DATE: 10.26.2018
TO: ProTrak
FROM: Mitesh Baxi
Traffic Engineering

■ **GREENLAWN FUNERAL HOME [TRC Plan Review #2]**

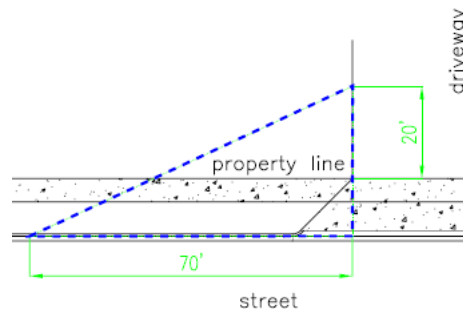
- Existing condition sheet does not depict the correct lane configuration on Shipyard Blv. The existing condition does not have right turn lane. Please revise.
- Show the skip lines pavement markings for the new turn lane. [NCDOT/City Standards]
